Item 3.**Development Application: 634 Botany Road and 45-47 Ralph Street, Alexandria
- D/2019/684****File No.:** D/2019/684**Summary****Date of Submission:** 28 June 2019. Amended plans and additional information were submitted up until 18 March 2020.**Applicant/Developer:** Lateral Estate P/L**Architect:** Smith & Tzannes**Owner:** Sameden P/L**Cost of Works:** \$45,728,777**Zoning:** B7 Business Park Zone**Proposal Summary:** Proposal

The subject application seeks consent for a concept building envelope for shop-top housing, including:

Figure 42: Sun's eye view of development adjacent to the south at 4 Gillespie Avenue.

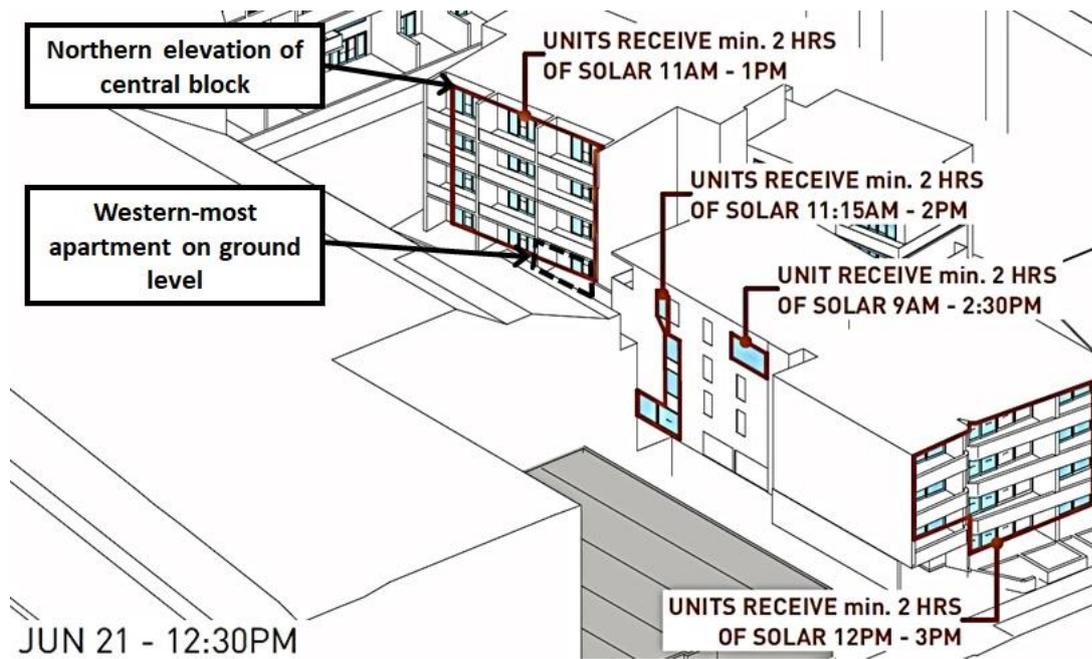
76. A similar error is made in the applicant's sun's eye view studies of solar access to the adjacent property to the south-west at 4 Gillespie Avenue. Again, the applicant's analysis counts apartments as achieving the minimum solar access requirements of the ADG, when they receive 2 hours of sunlight to their living rooms only.
77. The western apartment on the lowest level of the northern elevation of the central block, as shown in **Figure 42** below, does not receive 2 hours of solar access to its private open space.

78. The other north-facing apartments in the central block do appear to receive at least 2 hours of sunlight to both living room windows and private open spaces. However, without plans for the whole of the development at 4 Gillespie Avenue it cannot be ascertained as to whether solar access is retained for at least 70% of the apartments in that neighbouring development.
79. The development at 4 Gillespie Avenue comprises 102 apartments. It is considered that the loss of one apartment from the overall tally is unlikely to significantly change the percentage of apartments that do achieve the minimum solar access requirements of the ADG.
80. To address this concern, a condition is recommended for improvements to solar access to neighbouring apartments to be investigated through the competitive design process and subsequent detailed design development.

Figure 43: The arboricultural impact assessment report (the AIA report) shows trees 4, 5 and 6 will be significantly affected by the development.

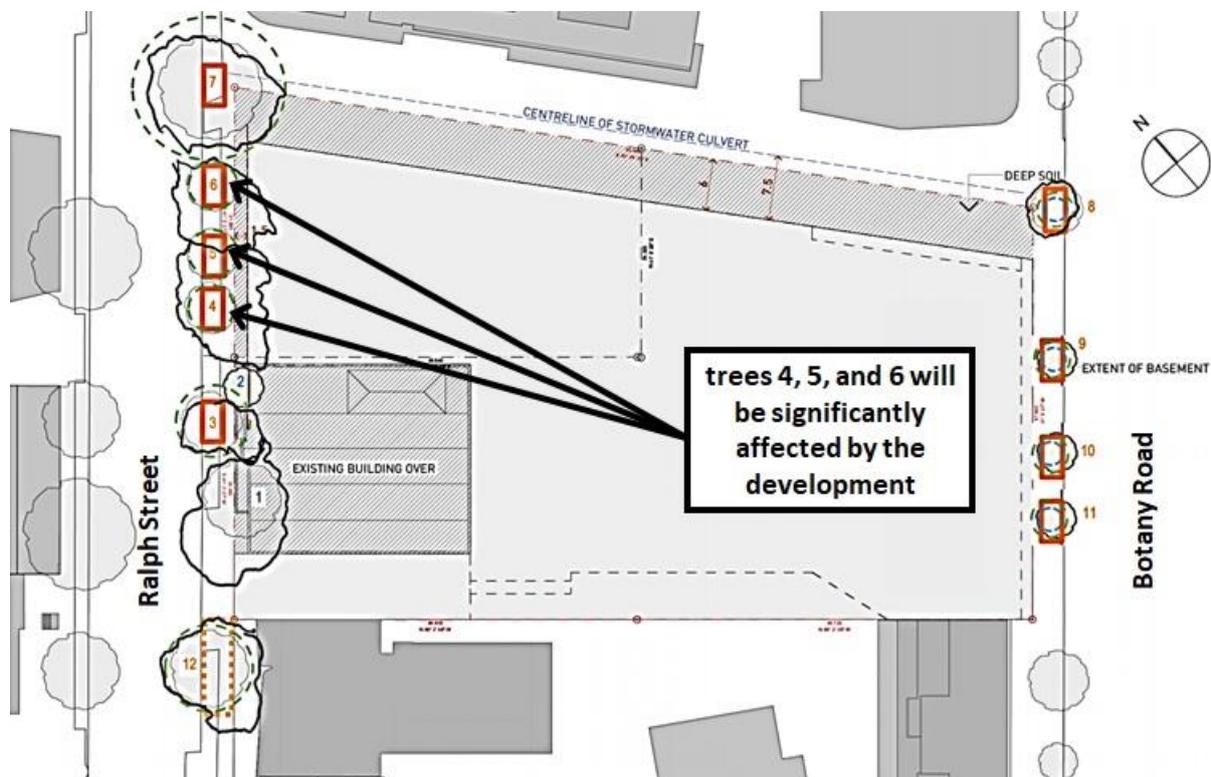
90. As shown in **Figure 43** above, taken from the submitted arboricultural impact assessment report (the AIA report), street trees numbered 4, 5 and 6 will be significantly impacted by the development.

Figure 44: Street trees leaning over the subject site.

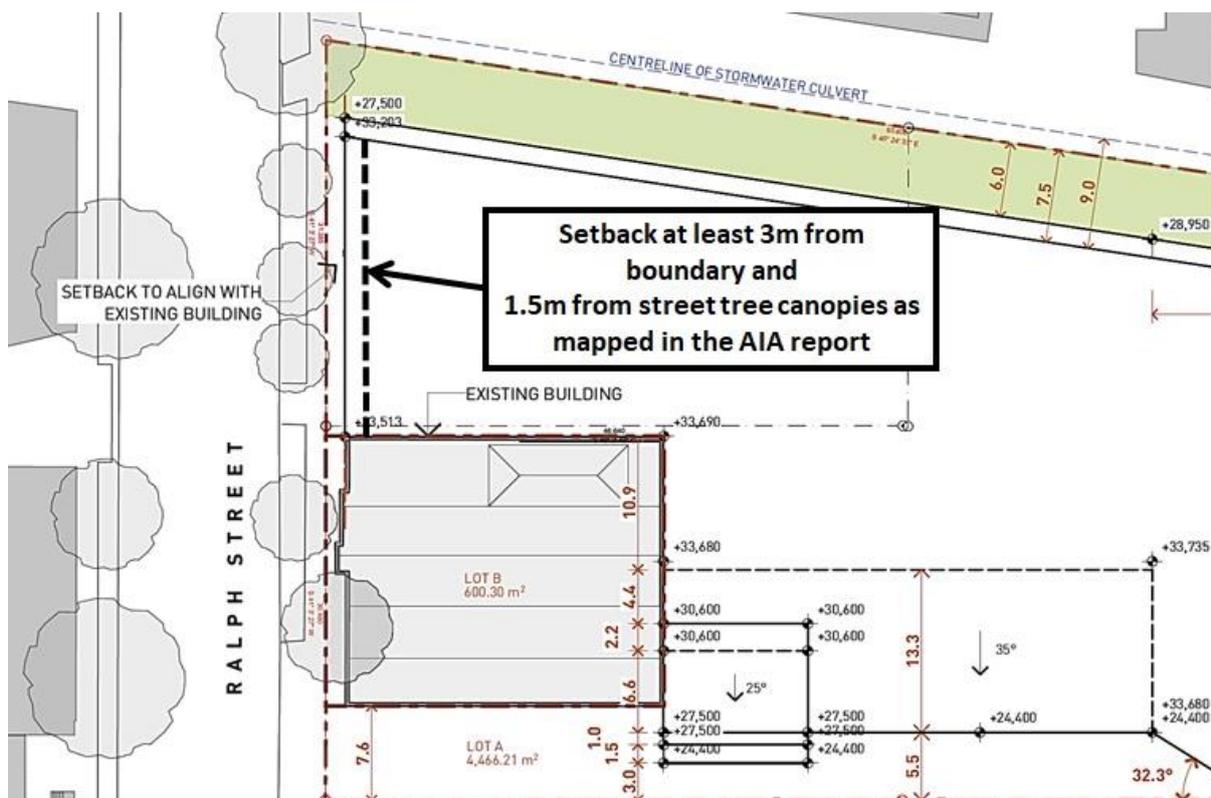
94. In accordance with these controls and the advice from Council's Tree Management, Landscape and Urban Design Specialists, a condition is recommended for design modifications to the envelope to set back its upper levels a minimum of 3m from the boundary with Ralph Street and a minimum of 1.5m from the canopies of street trees in Ralph Street. Refer to **Figure 44** below.

95. In addition to the condition described in the paragraph above, Council's Tree Management Specialist has recommended conditions to protect street trees and to address other shortfalls in the AIA report and associated DA documents, as follows:
- (a) design modifications for the envelope plan to include the tree canopy spreads as identified and illustrated in the AIA report;
 - (b) that the landscape concept plan be modified to include the minimum 15% canopy cover target and minimum 10% deep soil requirements for the site;
 - (c) requiring that any OSD tank and associated structures and services must not be located within the structural root zones of trees identified for retention; and
 - (d) specifying tree-related information to be submitted at the detailed design DA stage.

Figure 45: Shadow diagrams showing solar access to TSL, 2-3pm at midwinter.

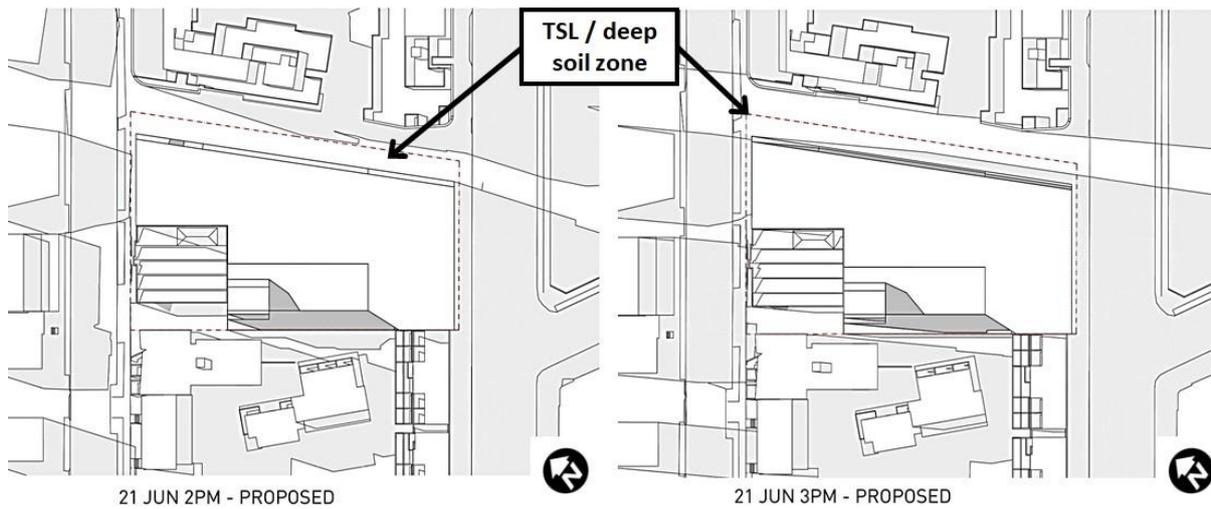
102. Despite its use as a TSL, the deep soil zone will still allow for filtration of water into the ground.
103. As shown in **Figure 45** below, in plan the submitted diagrams provided at hourly intervals, show that the TSL is mostly in shadow, except for about an hour between 2 and 3pm at midwinter.

Figure 46: Sun's eye view drawings showing sun access to TSL, 1-1.30pm at midwinter.

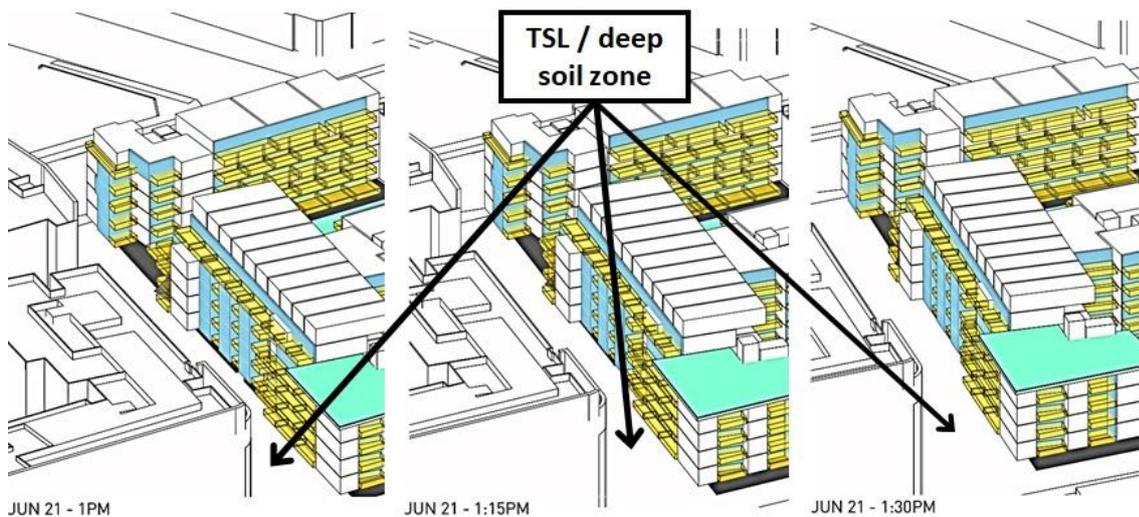
104. However, as shown in **Figures 46 to 48** below, the sun's eye view diagrams provided in 15-minute intervals, show that part of the TSL receives sunlight along its full length between 1 and 3pm.

105. Accounting for all the above, it is considered that the proposed deep soil zone provided in the TSL fulfils the deep soil objectives of the DCP and ADG within the constraints of the site.
106. To address the concerns about deep soil outlined above, conditions are recommended for modifications to the landscape concept plan to include design principles for the deep soil zone / TSL:
- (i) to provide at least 560sqm of deep soil in the TSL;
 - (ii) to maximise filtration of rainwater into the ground;
 - (iii) to accommodate large tree plantings;
 - (iv) to facilitate its use as a pedestrian connection between Botany Road and Ralph Street; and
 - (v) to address CPTED and safety concerns for users of the TSL.

Figure 50: Approximate location of apartment from which photo above was taken.

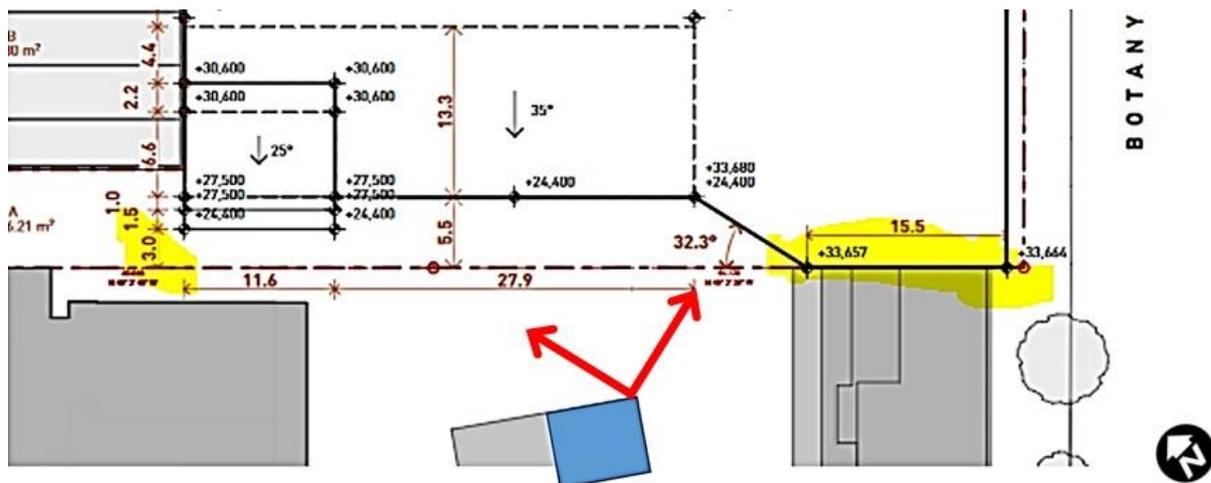
111. An objection was received raising concern that the proposed massing will obstruct city skyline views from upper level apartments to the south-west at 4 Gillespie Avenue. The relevant planning controls make no provision for the protection of private views. Nonetheless, in order to understand the view loss impacts of the proposal, the following assessment of view loss impacts is in accordance with the planning principles established by the Land and Environment Court decision of *Tenacity Consulting v Warringah [2004] NSWLEC 140 (Tenacity)*.
112. The proposal's impacts upon distant views from apartments within the residential apartments noted above are assessed according to the four-step process established in *Tenacity*, as follows.

113. Views to be affected - the photo at **Figure 49** above shows partial views of a handful of the tallest buildings on the city skyline. According to *Tenacity*, these views are of a low value.
114. From what part of the property are the views obtained - the objector that provided the photo at **Figure 49** above has advised that the photo was taken from the balcony of the apartment. The views are across neighbouring properties to the north and to the skyline in the distance.
115. Extent of the impact - the proposed envelope is at least a storey higher than the apartment from which the photo at **Figure 49** was taken. It is likely that views to the city skyline will be blocked. The impact is minor in the terms established in *Tenacity*.
